## RB34-04/05

### R301.2.1.3, Table R301.2(1), R202

**Proponent:** Jason Smart, Institute for Business & Home Safety, Tampa FL

**FIGURE 4.4**  
**APPLICATION OF LIVE LOAD REDUCTIONS**

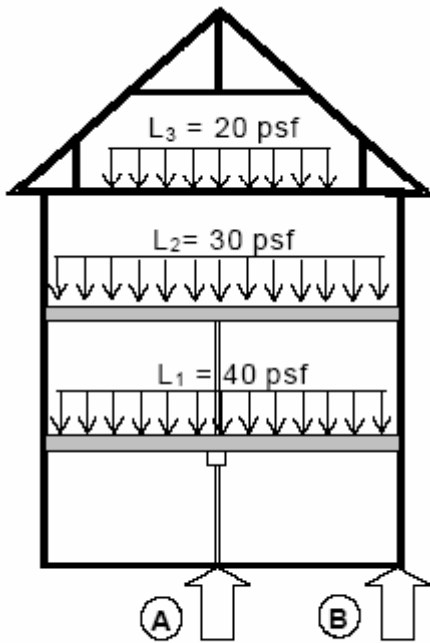
From the section 4.4 Commentary: "The uniform live load values for floors in Table 4.1 are based on a floor area of 200 square feet. As the floor area under consideration becomes larger than 200 square feet, the potential for a large uniform live load over the entire area decreases. The equation for live load reduction makes this adjustment specifically for residential occupancies. The equation used in existing building codes and standards is based on commercial buildings.

The approach of combining multiple sources of live loads (multi-story construction) provides a conservative adjustment, not on the basis of floor area supported, but rather on the basis of the statistical "independence" and the improbability of maximum live loads occurring on different stories of the dwelling at the same time."

Figure 4.4 is included from HUD, Structural Design Loads for One- and Two-Family Dwellings, to illustrate how these reductions might be applied.
